**Re: Response to ADEQ Correspondence Dated August 3, 2015
First Quarter 2015 Progress Report – May 2015
Whirlpool Corporation
Fort Smith, Arkansas
EPA No. ARD042755389
AFIN No. 66-00048
CAO LIS 13-202**

Ramboll Environ US Corporation (Ramboll Environ), on behalf of Whirlpool Corporation, is submitting this response to Arkansas Department of Environmental Quality's (ADEQ) August 3, 2015, comment letter on Whirlpool's correspondence dated July 15, 2015 regards Ramboll Environ's First Quarter 2015 Progress Report dated May 2015. ADEQ comments are provided in italics below and the respective response follows.

PROPERTY ACQUISITION MAP
JENNY LIND ROAD RELOCATION
BRAZIL TO JACOBS
FORT SMITH, ARKANSAS

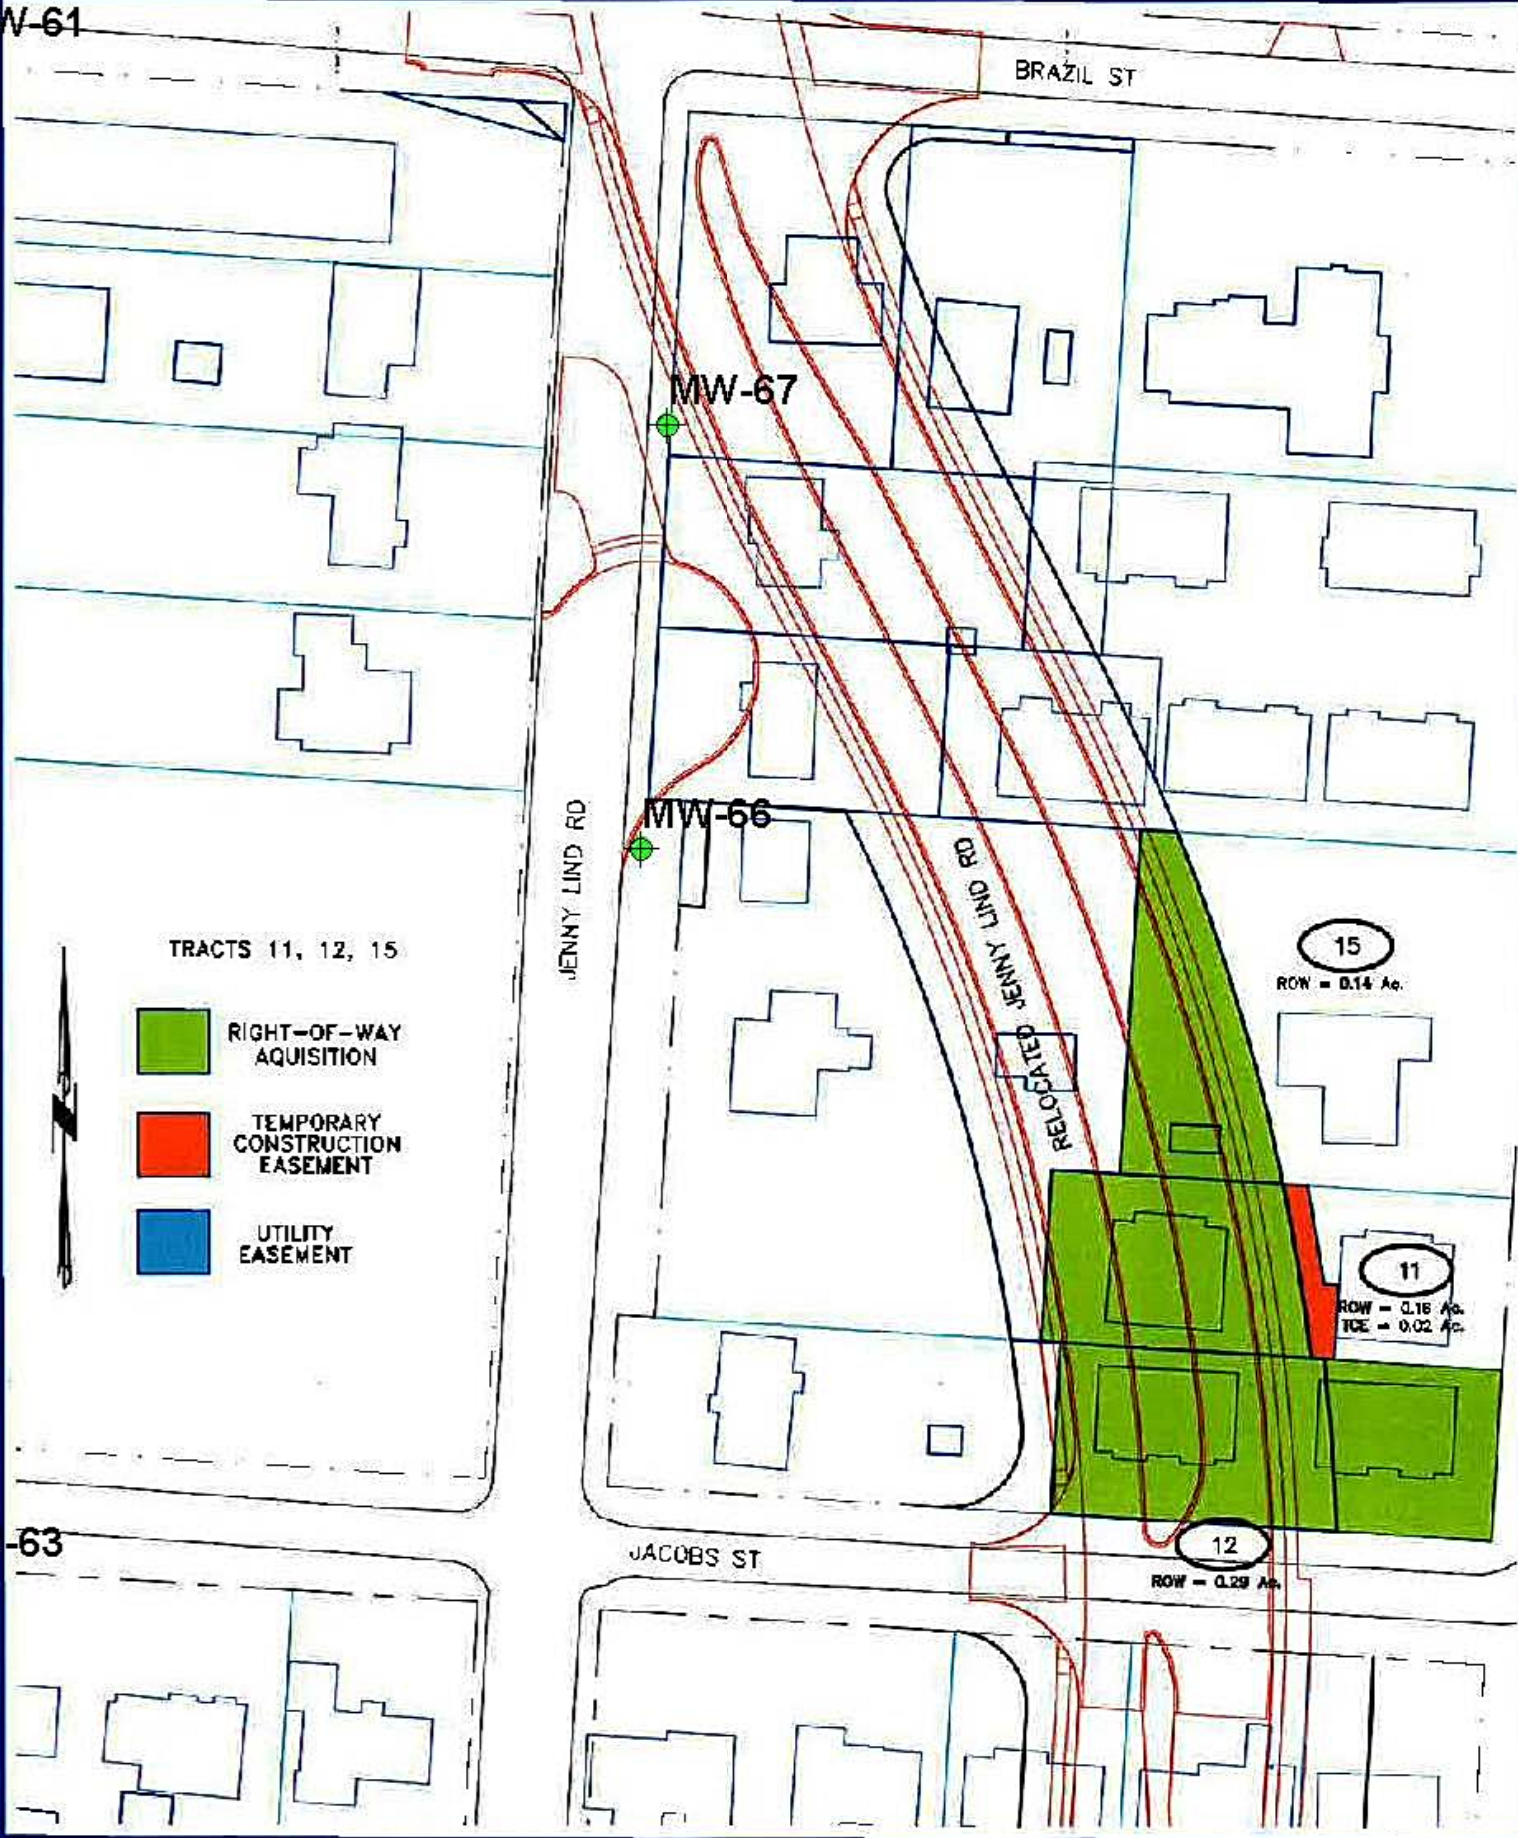
Volume 1, Section 3, Results, 3.3.1 VOC Results, Plume Boundary Wells: *DP-58 is not an acceptable location for a northern plume step-out monitoring well. The DP-58 location is north of the apparent path of the northern plume and the lithology reported at DP-58 indicated the presence of Hartshorne Shale at a depth of 11.5 feet below ground surface (bgs) overlain by silty clay. Please revise plans for the step-out well for the northern plume to be located east of MW-67 and MW-66 directly down-gradient of the center line of the northern plume.*

The pending Jenny Lind Road re-alignment project will include positioning the new Jenny Lind Road on the properties east of the existing Jenny Lind Road. We have attached the figure from the City of Fort Smith depicting the monitoring well locations and proposed new and existing Jenny Lind Road alignments (the road alignments on the attached figure have been depicted on the potentiometric surface maps in the 2014 Annual Report and the 2015 First Quarter Progress Report). The figure shows the properties east of MW-66 and MW-67 are encompassed by the pending road re-alignment project.
